## **ADDENDUM No. 1**

### **RFP No. 25-37**

## **FALL 2025 & SPRING 2026 STREET TREE PURCHASE & PLANTING**

## TREE PLANTING DETAIL

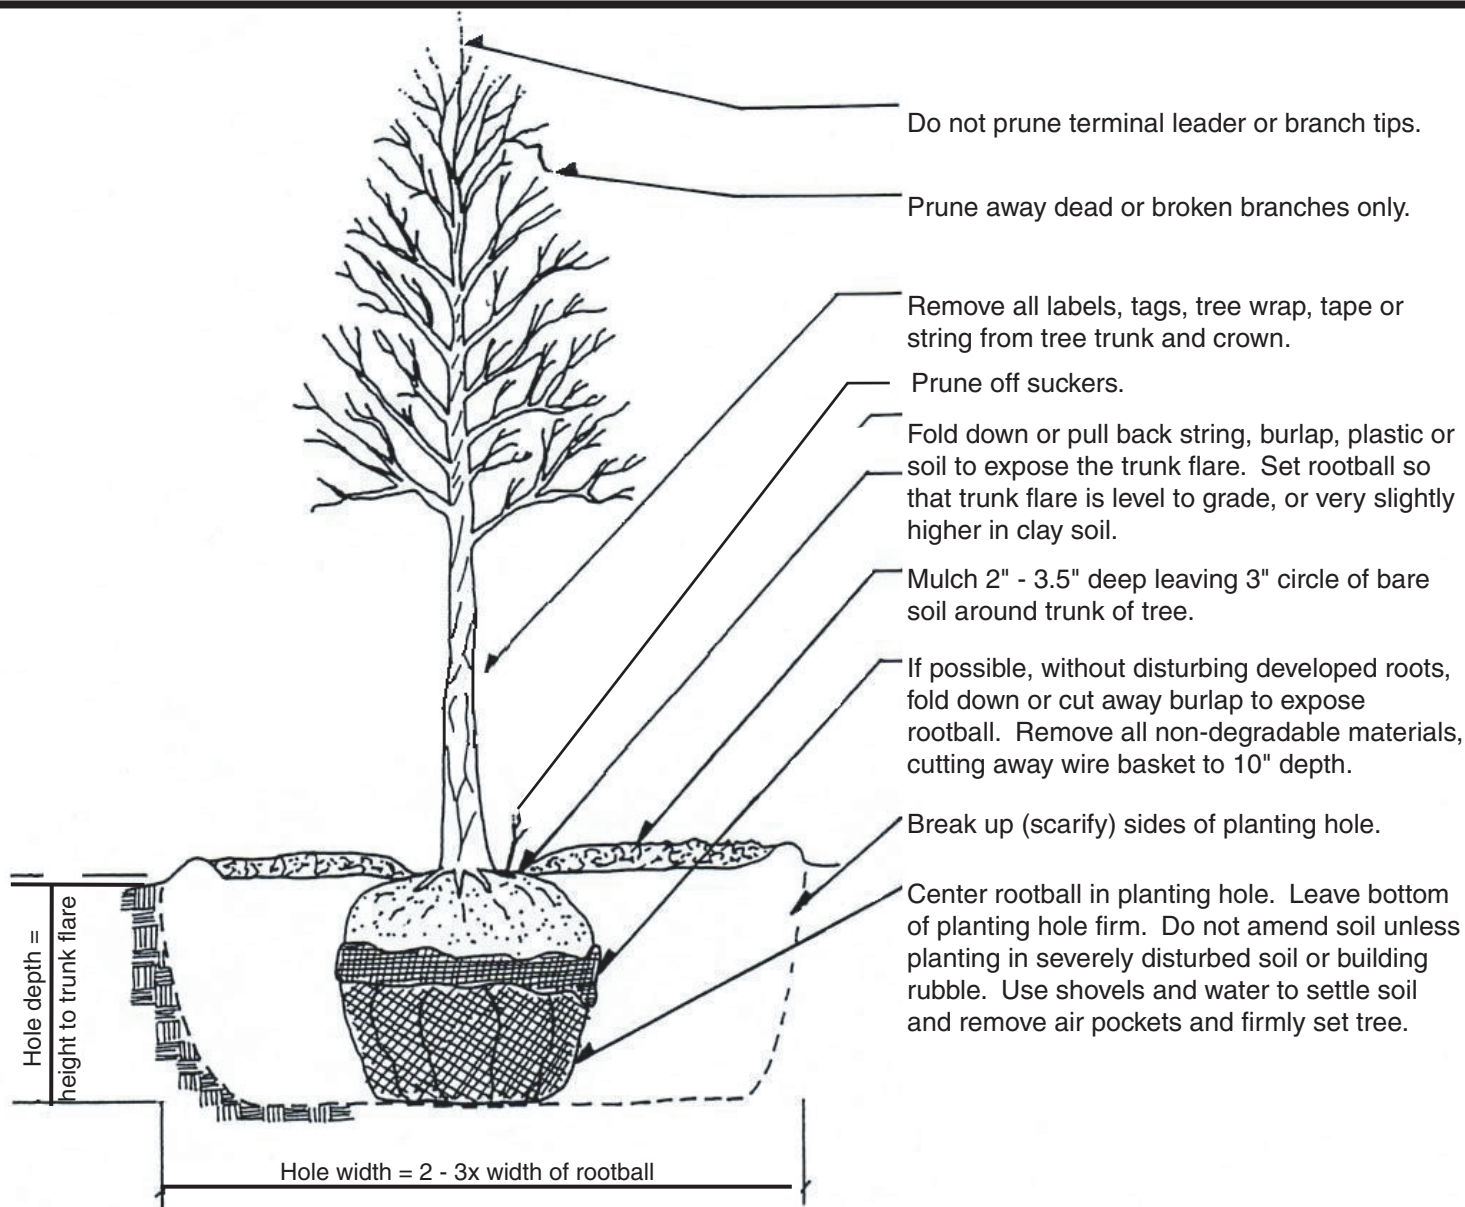
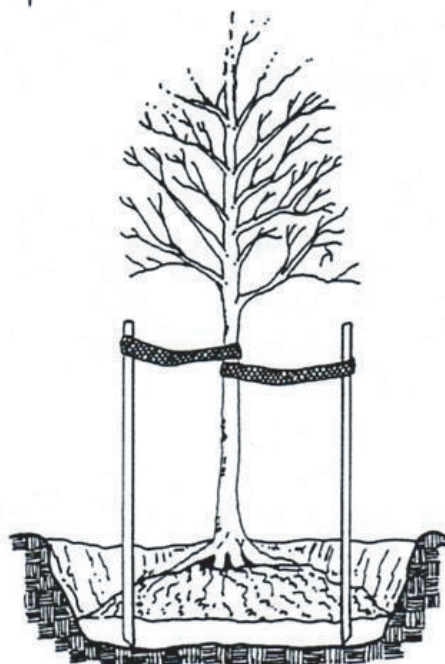
Question 3: "On a similar note, Section 7D states that *the contractor shall excavate planting areas as shown on the City of Ann Arbor Tree Planting Detail (Appendix B)*, and Section 8H says *planting areas shall be finish-graded to conform to drawings (refer to Appendix I - Tree Planting detail).* The only appendix I see within this

document is Appendix A (Proposed Planting Areas: FY 2026). Where are the other appendices?"

Answer 3: The Tree Planting Detail appendix, that was inadvertently omitted from the RFP Document, is included herein. This detail will illustrate both the excavation and finish-grade details.

*Do not* stake unless in heavy clay soil, windy conditions, 3" or greater diameter tree trunk or large crown. If staking is needed due to these conditions:

- Stake with 2 x 2 hardwood stakes, or approved equal, driven 6" - 8" outside of rootball.
- Loosely stake tree trunk to allow for trunk flexing.
- Stake trees just *below* first branch with 2" - 3" wide belt-like, nylon or plastic straps (2 per tree on opposite sides of tree, connect from tree to stake horizontally. *Do not* use rope or wire through a hose.)
- Remove all staking materials after 1 year.
